Product Change Notice (PCN)

PCN Number: **PCN-0451151R-01**

Product(s) Affected: PJ-037BH

Description of Change: mechanical differences as shown below:

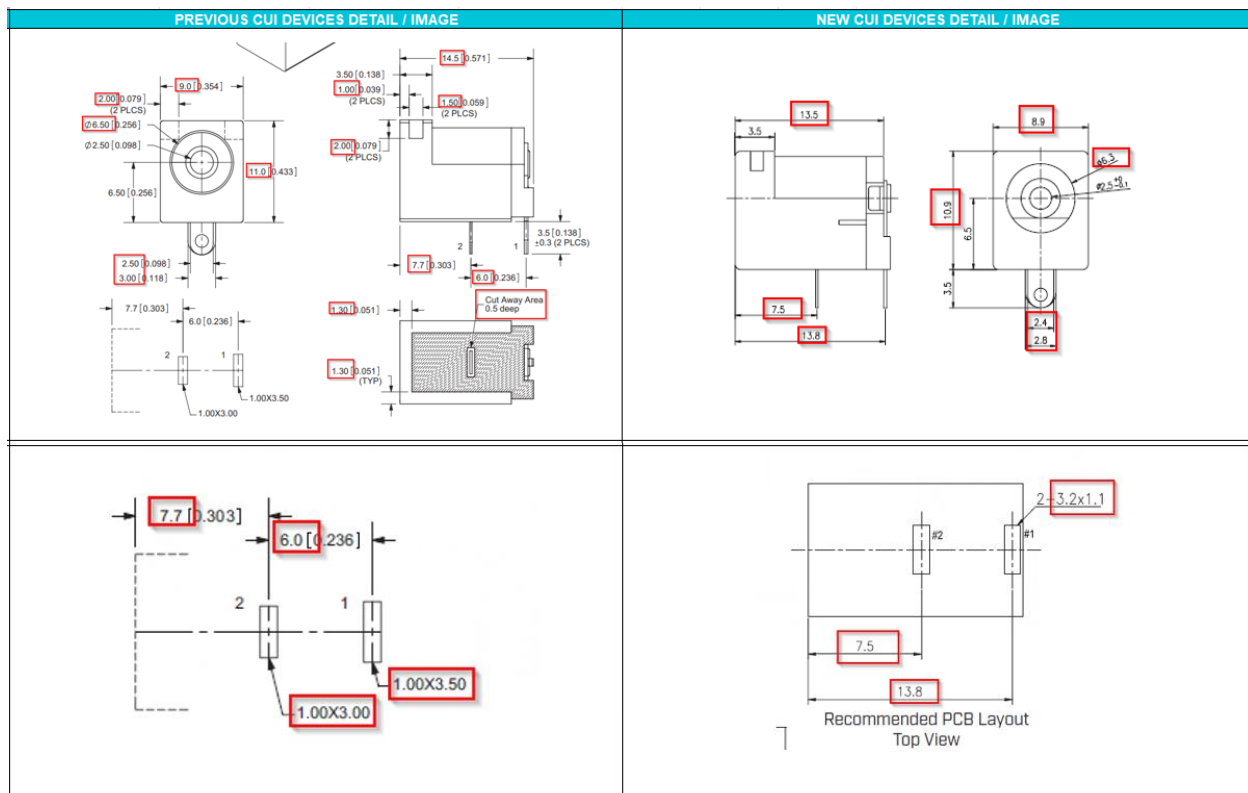
<table border="1"> <thead> <tr> <th></th> <th>MATERIAL</th> <th>PLATING</th> </tr> </thead> <tbody> <tr> <td>center pin</td> <td>copper</td> <td>nickel</td> </tr> <tr> <td>terminal 1</td> <td>brass</td> <td>silver</td> </tr> <tr> <td>terminal 2</td> <td>copper alloy</td> <td>silver</td> </tr> <tr> <td>plastic</td> <td>PBT</td> <td></td> </tr> </tbody> </table>		MATERIAL	PLATING	center pin	copper	nickel	terminal 1	brass	silver	terminal 2	copper alloy	silver	plastic	PBT		<table border="1"> <thead> <tr> <th>DESCRIPTION</th> <th>MATERIAL</th> <th>PLATING/COLOR</th> </tr> </thead> <tbody> <tr> <td>center pin</td> <td>copper alloy</td> <td>nickel</td> </tr> <tr> <td>terminal 1</td> <td>brass t=0.3 mm</td> <td>nickel-silver</td> </tr> <tr> <td>terminal 2</td> <td>phosphor bronze t=0.3 mm</td> <td>nickel-silver</td> </tr> <tr> <td>housing</td> <td>PBT (UL94V-0)</td> <td>black</td> </tr> <tr> <td>cover</td> <td>PBT (UL94V-0)</td> <td>black</td> </tr> </tbody> </table>	DESCRIPTION	MATERIAL	PLATING/COLOR	center pin	copper alloy	nickel	terminal 1	brass t=0.3 mm	nickel-silver	terminal 2	phosphor bronze t=0.3 mm	nickel-silver	housing	PBT (UL94V-0)	black	cover	PBT (UL94V-0)	black

MATERIAL	PLATING																																
center pin	copper	nickel																																
terminal 1	brass	silver																																
terminal 2	copper alloy	silver																																
plastic	PBT																																	
DESCRIPTION	MATERIAL	PLATING/COLOR																																
center pin	copper alloy	nickel																																
terminal 1	brass t=0.3 mm	nickel-silver																																
terminal 2	phosphor bronze t=0.3 mm	nickel-silver																																
housing	PBT (UL94V-0)	black																																
cover	PBT (UL94V-0)	black																																
 <p>MATING PLUG Jack Insertion Depth: 9.0 mm</p>	 <p>MATING PLUG Jack Insertion Depth: 9.8 mm</p>

Insertion/extraction force adjusted to 0.3 ~ 2.0 kg
